# Product Safety Recall

## N222391080 Defective Suspension Nuts

**Revision:** 01

**Revision Description:** This bulletin is being revised to update the Service Procedure. Please discard all previous copies of N222391080.

4926623

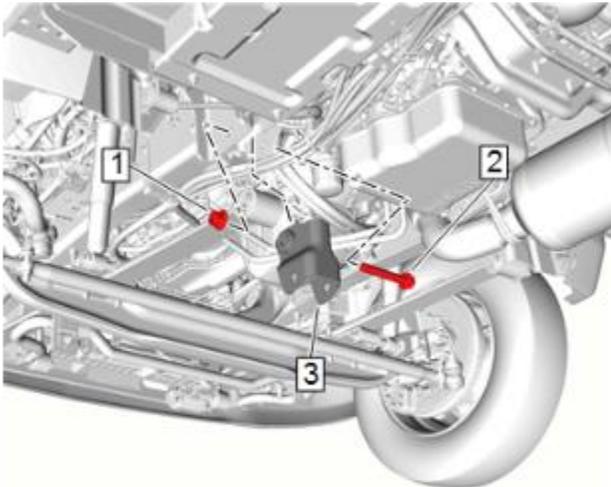
2. One at a time, remove and replace both of the Front Leaf Spring Shackle Nuts (1) on the left side of the vehicle, torquing to 407-502 Nm (300-370 lb ft).

**Caution:** Do not remove both nuts at the same time. Remove, replace, and torque each nut individually before moving to the next one.
